Revisions to Orphaned Well Program Costs for Financial Assurance Rulemaking

Colorado Oil and Gas Conservation Commission Orphaned Well Program

July 23, 2021

Orphaned Well Program Sample Data Set: Costs by Work Type

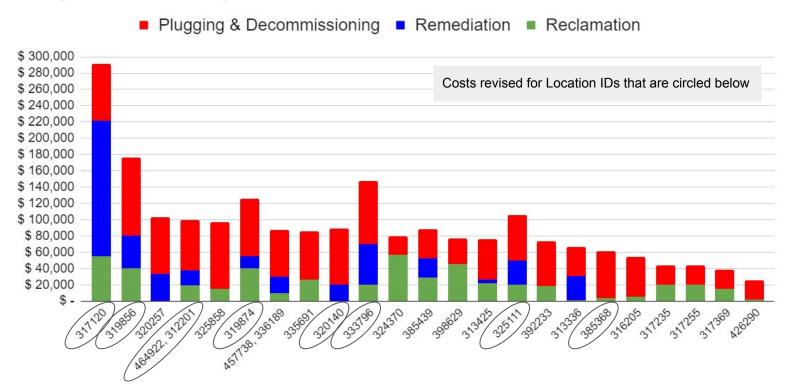
- Recent information requests from Financial Assurance stakeholders resulted in additional review of the information for the 23 sites.
- Costs have been added for work being performed or contemplated by Oil and Gas Operators on Public Projects related to enforcement. The costs will not affect the OWP Bond or Appropriation budgets because they are paid by the operator for the Public Project. The costs are added here to provide a more complete picture of the costs that the program would face without the assistance of a Public Project.
- Estimated environmental costs have been added for 5 sites and updated for 1 site.
- OWP work since May 5 has allowed us to replace estimated costs with actual costs for 3 sites.

Location IDs in the same order, after revising costs

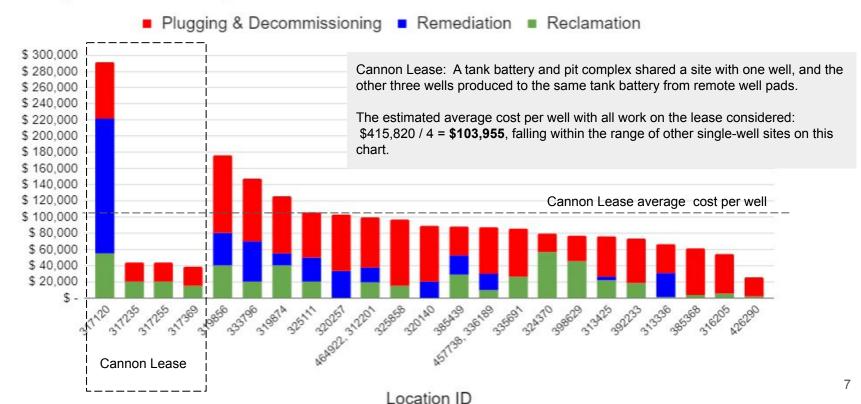
How do these revisions affect the May 5 statistics?

Total site costs ranged from \$25,485 to \$144,290 \$291,068

Average cost and median cost of \$77,278 \$92,710 and \$77,759 \$85,438, [per site] respectively.

Plugging and Decommissioning costs ranged from \$22,567 to \$83,600 \$95,922, with an average cost of \$50,925 \$52,141.

Environmental costs ranged from \$0 to \$33,240 \$166,698.
